Development application 2023.338
Lot: 50 DP: 1109545 - 19-21 Weecoon Street EDEN

We received your development application on 23 January 2023. A detailed assessment of the application has been undertaken and unfortunately there are various matters that require further clarification.

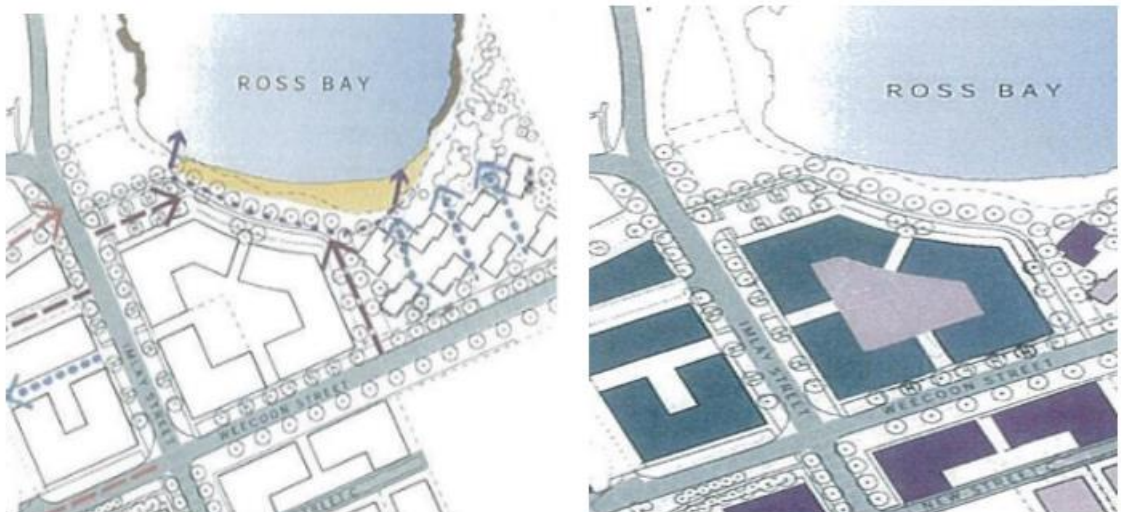
11. The demarcation line between Stage 1 and the subsequent stages appears to be in the middle of the area denoted as "Restaurant Access" which consists of a number of stairs in a landscaped setting. Please confirm whether the full extent of the landscaping and stairs will be provided or only partial width, as well as detail any interim fencing or other measures to prevent access to the remaining stages. All plans are to be fully dimensioned.

Figure 6-1. Preliminary Edge Treatment Sketch – Option 1A (based on Michael Reeves Concepts)

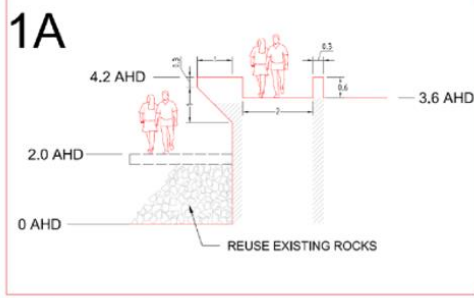
Refers to a preliminary Edge Treatment Sketch (Figure 6-1) that show reuse of existing rocks, a concrete seawall with overhang and pathways including one suspended, mostly in front of the future stages. Recommended works would be at approx. 5.5m AHD. Clear indication that works have been considered as part of “Stage 1” of the development and the principal function of the works is to limit shoreline erosion and recession.

Page 7.13 refers to 4 zones (however the extent of these are not mapped). Section 7.0 refers to revised architectural designs prepared by the architect with 4 seawall types (see Appendix F in the report) and refers to the works as “shoreline protection works” and reuse of rocks within the back-beach, albeit not as an engineered structure. Page 7.14 also refers to “the (pile) foundations for Stage 1 will need to be socketed into the bedrock – ELK to determine with J&K.”

Zone 1- CASE B

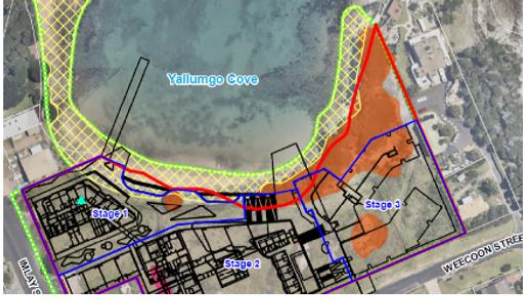
Untitled photomontage shows part of the Northern boundary to the Bay (Between the Stage 1 line and Zone 4 line) will be subject to works as shown in Figure 1A above (or similar), noting that the final design depends on the architectural response – which does not appear to have been resolved.

The provided Sections (described as Stage 1 and Zone 1) indicate structures within 15m and 5.5m (respectively) of the “property limit”.

Civil Engineering Plan:

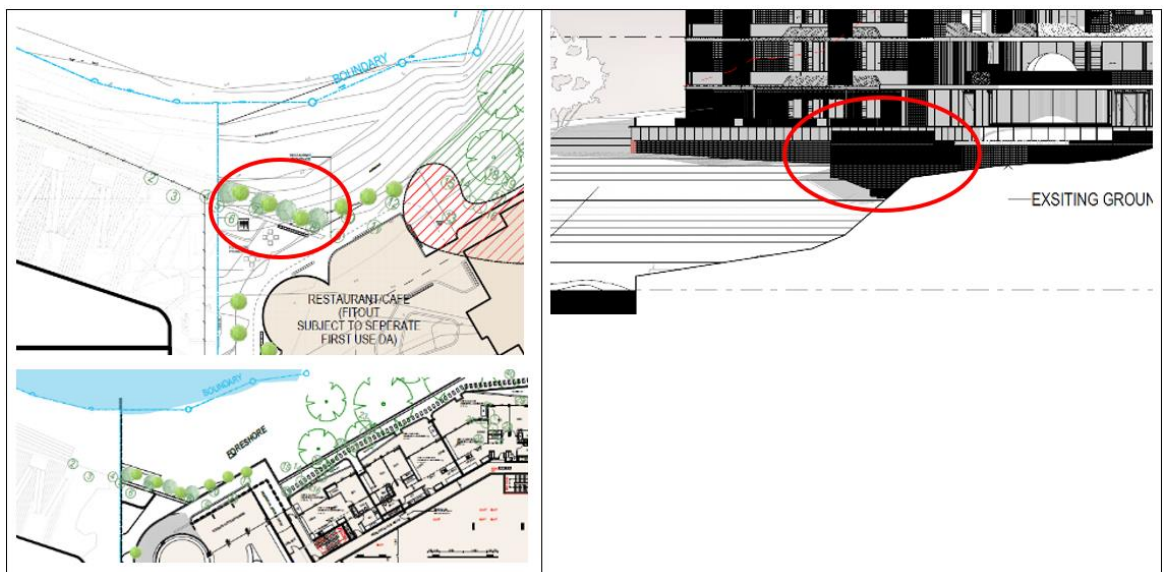
Shows a stormwater outlet with tidal gate at 0.6m AHD. MHW is at 0.38m AHD Works appear to be partly outside the Site and may extend below MHW.

Flora and Fauna Report:

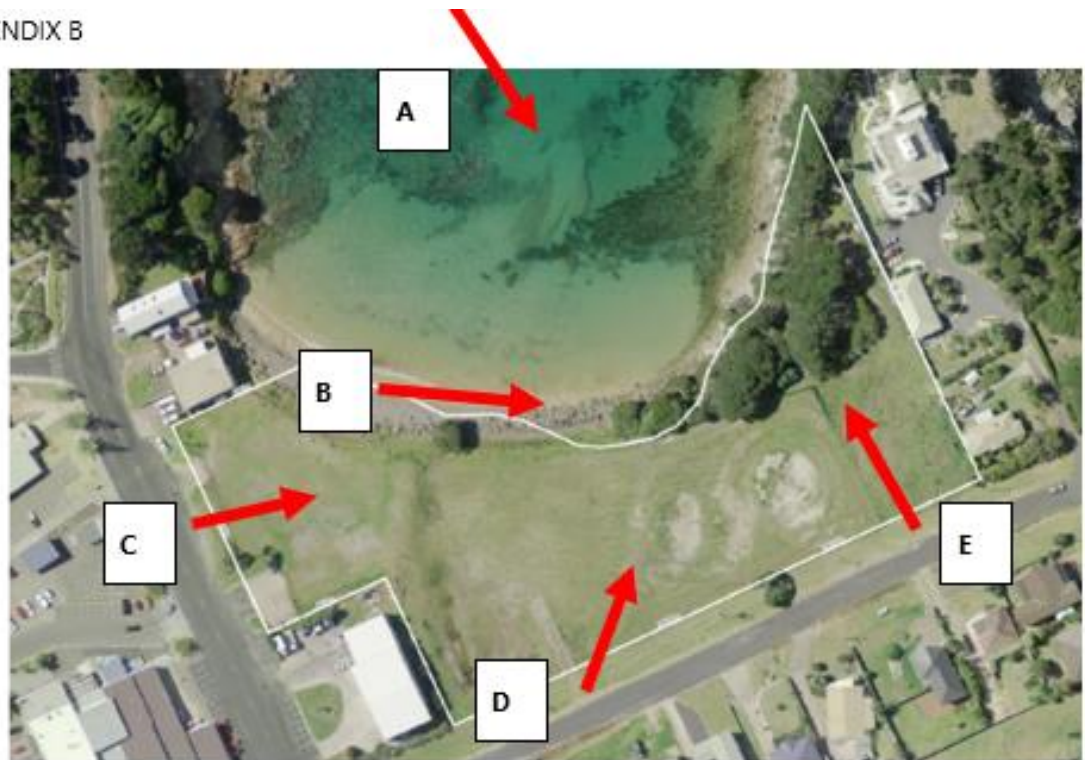
Indicates two structures projecting into the bay and different staging. Additionally, the blue staging boundary for Stage 3 appears to extend over
